STAFF RECOMMENDATION
2202 9th Avenue South
February 15, 2017

Application: New construction—addition and outbuilding; Setback determination
District: Waverly-Belmont Neighborhood Conservation Zoning Overlay
Council District: 07
Map and Parcel Number: 10513040100
Applicant: Juri Hall, JDH
Project Lead: Melissa Baldock, melissa.baldock@nashville.gov

Description of Project: Application is for partial demolition, the construction of an addition, and the construction of a seven-hundred and eighty one square foot (781 sq. ft.) outbuilding. The outbuilding, which will not be used as a dwelling unit, requires a change to the rear setback.

Figure 4 (left) shows the extension to be removed and Figure 5 (right) shows the 1957 Sanborn Map.

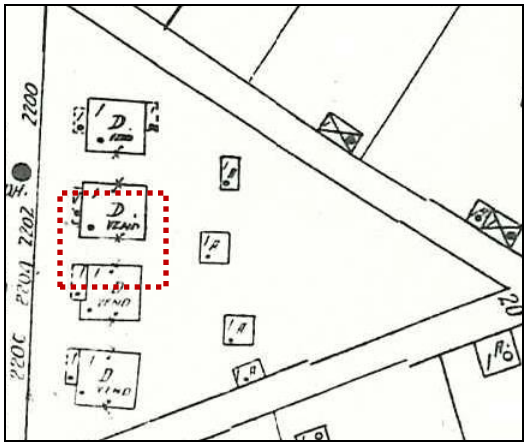
The applicant also intends to remove a small rear extension (Figure 4). The date of construction of the extension is not known, but it does not appear on the 1957 Sanborn map (Figure 5). Staff finds that the small, one-story addition's date of construction, materials, roof form, and design do not contribute to the historic character of the house or the Waverly-Belmont neighborhood.

With the condition that the applicant revise removing the existing window openings, staff finds that the proposed partial demolition meets Section V.B.2 for appropriate demolition and does not meet section V.B.1 for inappropriate demolition.

ENLARGED SITE PLAN

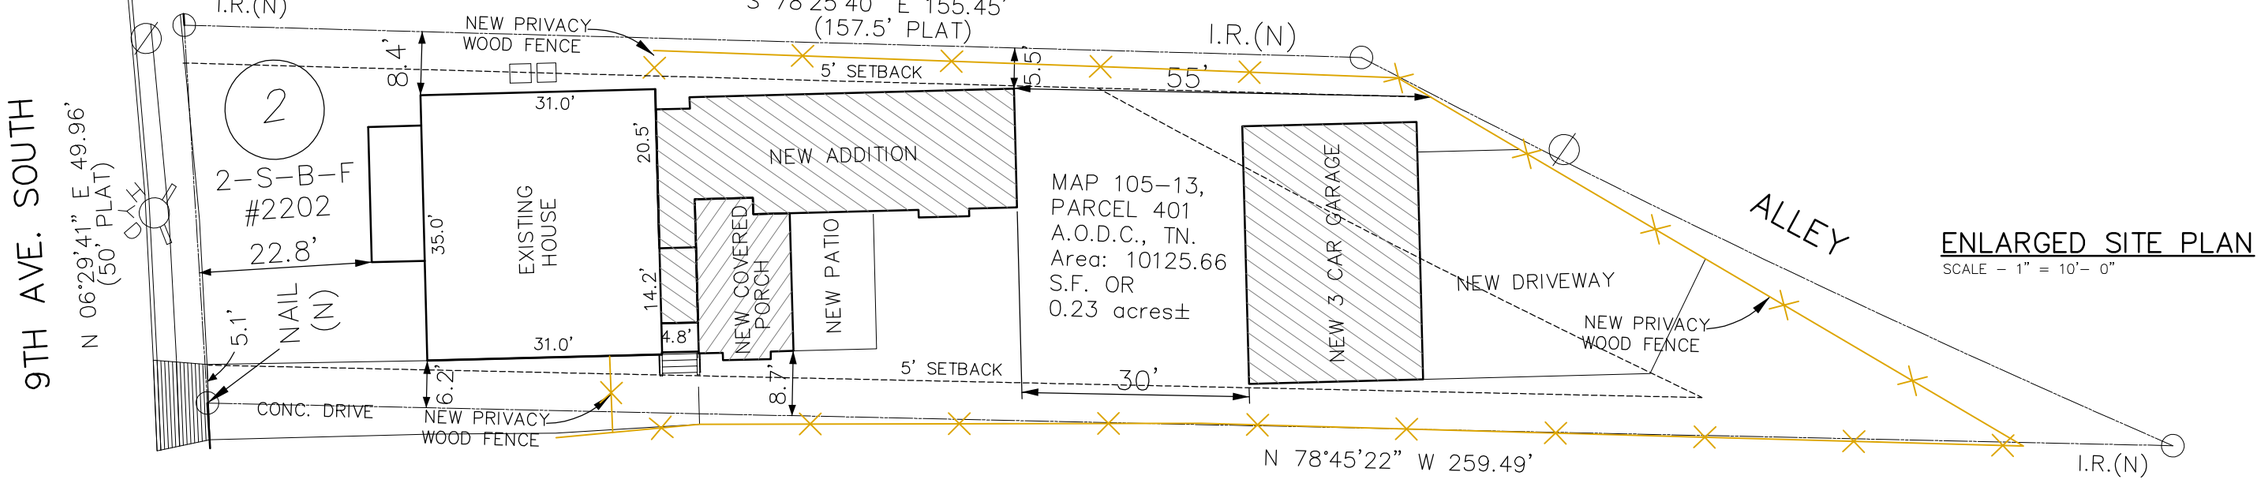
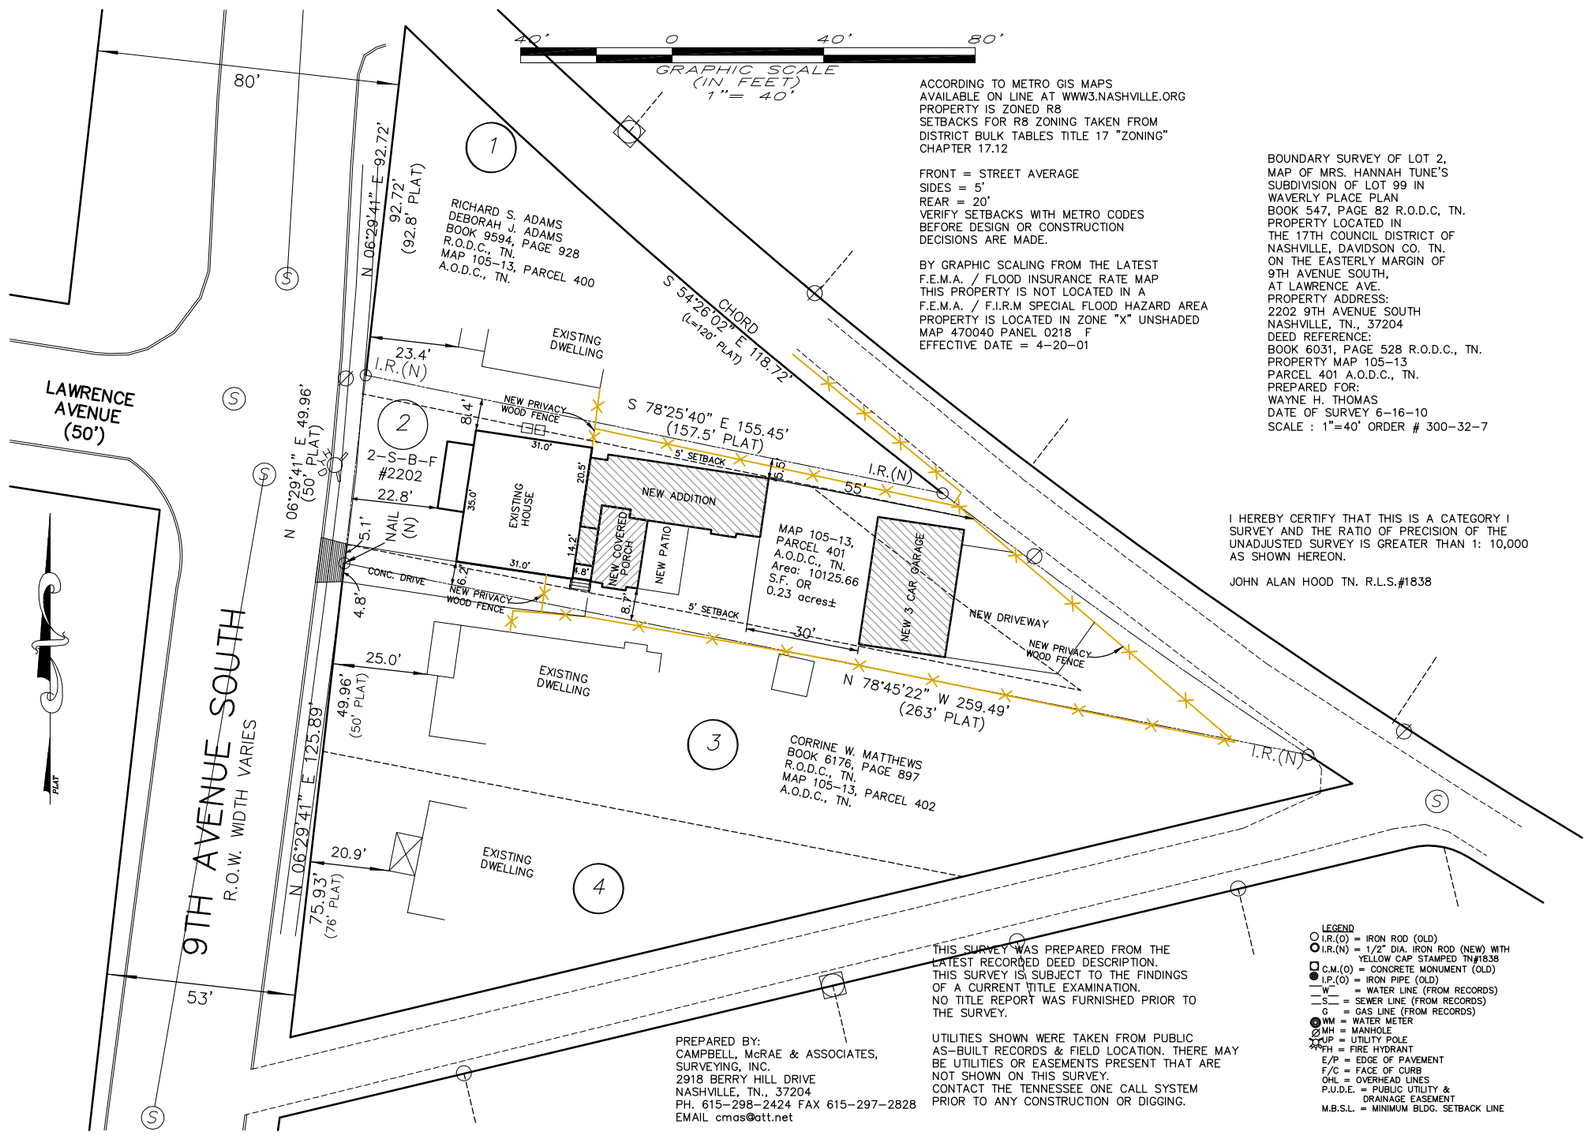
Setback & Rhythm of Spacing: The addition meets all base zoning setbacks. It will be a minimum of five feet, six inches (5'6") from the left side property line and eight feet (8') from the right side property line. It will be a minimum of fifty-five feet (55') from the rear property line. Since the addition is not wider than the historic house, it will not

MINIMUM	**PROPOSED**
Space between principal building and DADU/Garage	20’	30’
Rear setback	20’	10’-75’*
L side setback**	5’	5’
R side setback**	5’	5’
How is the building accessed?	From the alley or existing curb cut	Alley

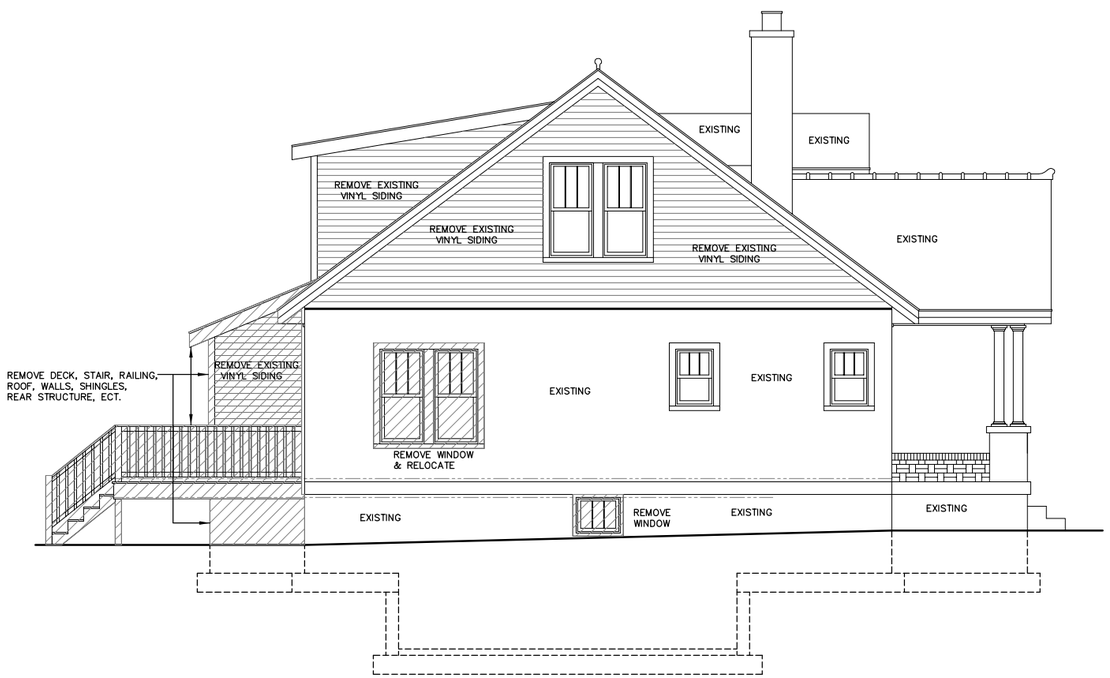
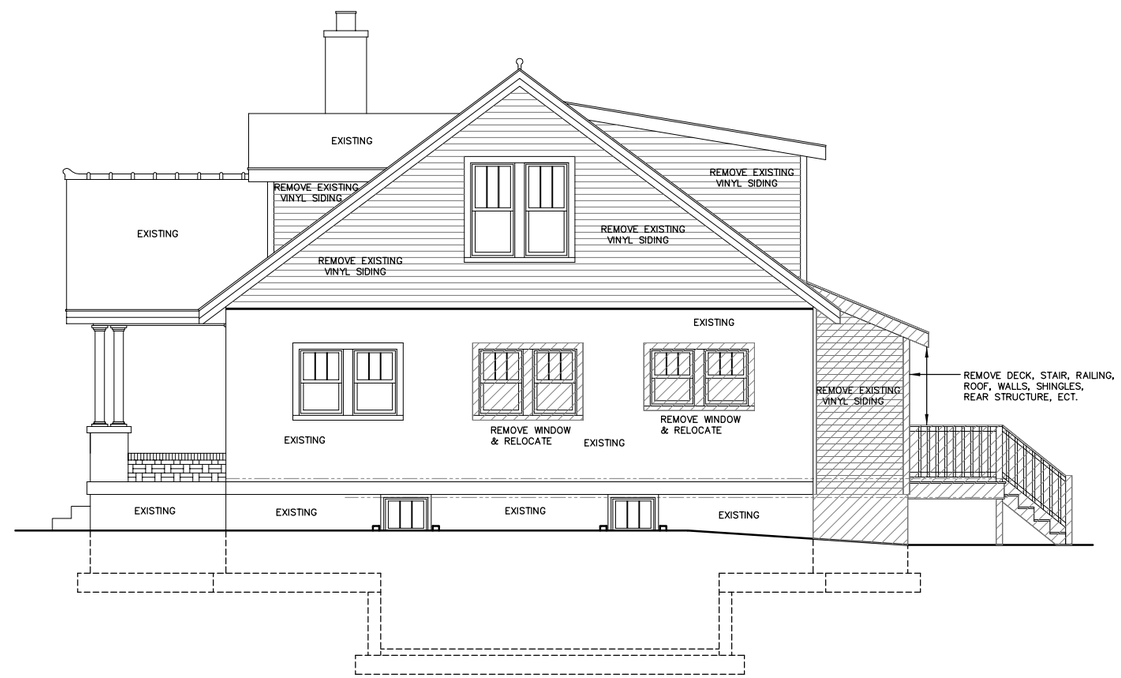
Partial Demolition: The applicant plans to alter window openings on the side façade, which is considered to be partial demolition. On the left façade, the applicant plans to remove a double window opening on the ground floor, towards the back (Figure 2). On the right façade, the applicant plans to remove two double window openings and replace them with a new window opening (Figure 3). Staff finds that the removal of all three windows is not appropriate, and staff recommends that the applicant retain the original window pattern to the greatest extent possible.

Figures 2 & 3 show the side window openings that the applicant proposes to remove.

NEW ELEVATIONS

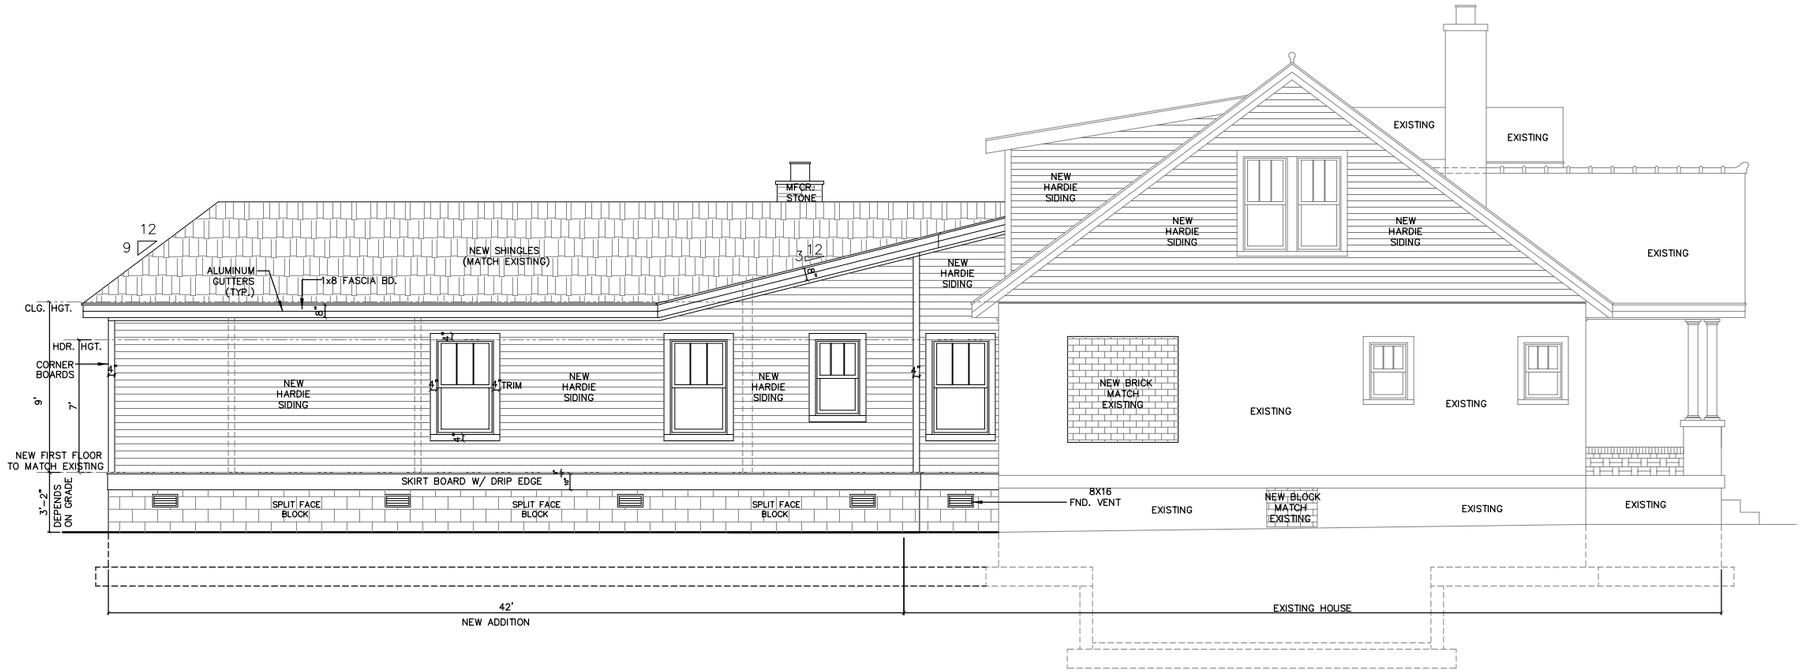
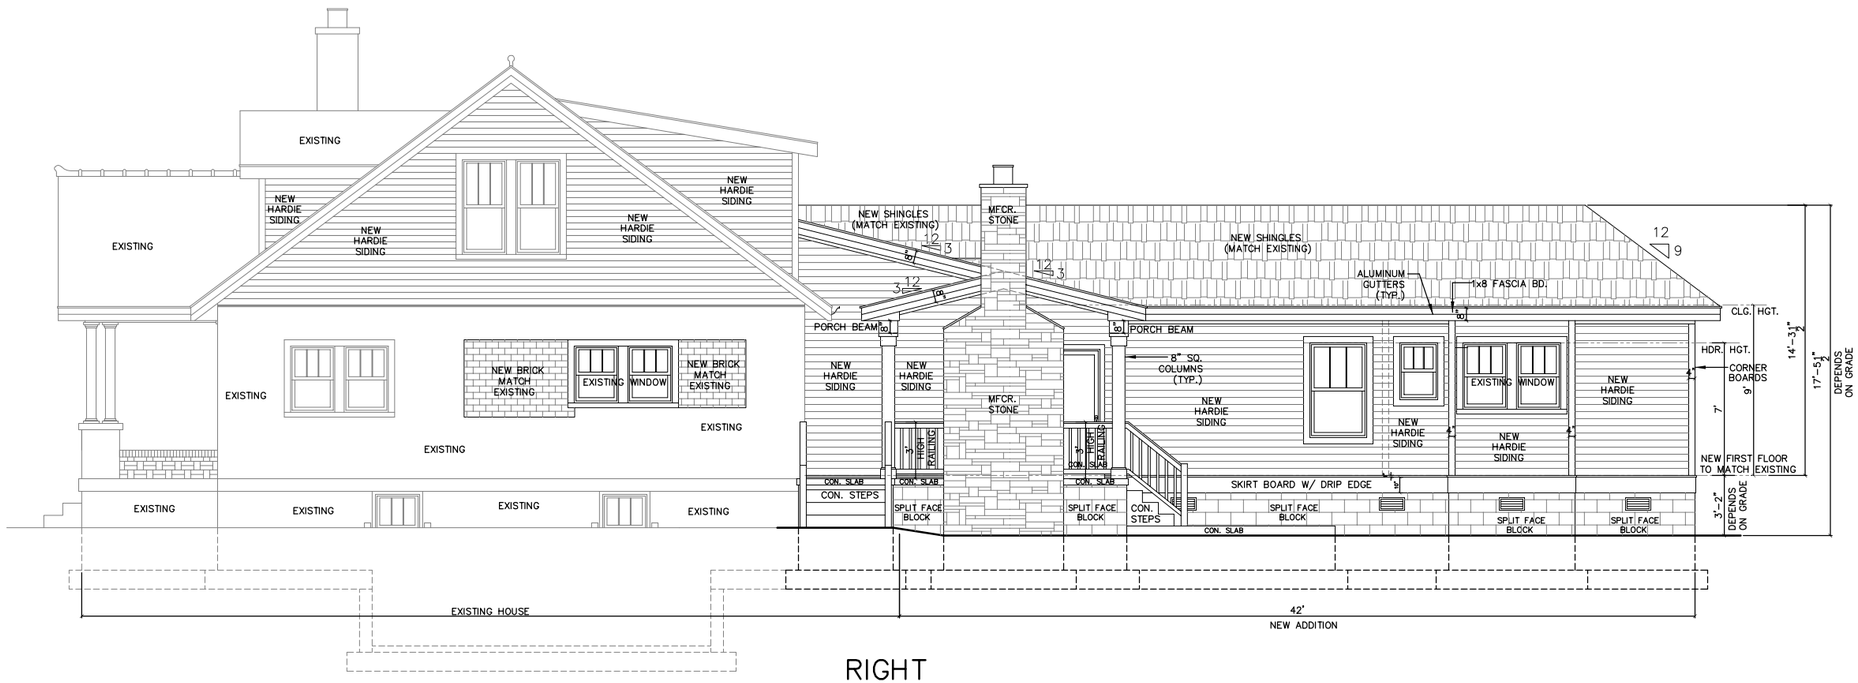
Height & Scale: The proposed addition will be one-story in height. The addition's foundation and eave heights will match those of the historic house. Its ridge height will be seventeen feet, five inches (17'5"), which is approximately seven feet (7') shorter than the historic house. The addition is inset from the back walls of the historic house by two feet (2') on the left side and four feet, one inch (4'1") on the right side. On the right side, after a depth of four feet, nine inches (4'9"), the addition steps back out to match the line of the house; this portion of the addition will be a covered porch that is seventeen feet, four inches (17'4") deep.

On the left elevation, after a depth of four feet, six inches (4'6"), the addition steps back out one foot (1') to be inset one foot (1') from the back corner of the house. This portion of the addition is long and narrow. It has an ultimate depth of fifty-one feet, ten inches, but is only fifteen feet, six inches (15'6") wide. By comparison the historic house is thirty-one feet (31') deep and thirty-five feet (35') wide. Staff finds the long left side portion of the addition to be appropriate because it is only one story and several feet shorter than the historic house. In addition, its narrowness keeps its massing and scale appropriate. The historic house has a footprint of approximately thirteen hundred square feet (1,300 sq. ft.), and the proposed addition will add approximately one thousand and forty square feet (1,040 sq. ft.) of footprint to the house.

The siding reveal was not indicated on the plans, and staff recommends that it be five inches (5") or less. Staff also recommends approval of a stone sample and all windows and doors prior to purchase and installation. With these conditions, staff finds that the known materials meet Sections III.D. and IV. of the design guidelines.

Proportion and Rhythm of Openings**:** See "Partial Demolition" for a discussion on the changes to the windows on the historic house. The windows on the proposed addition are all generally twice as tall as they are wide, thereby meeting the historic proportions of openings. There are no large expanses of wall space without a window or door opening. Staff finds that the project's proportion and rhythm of openings meet Sections III.G. and IV. of the design guidelines.
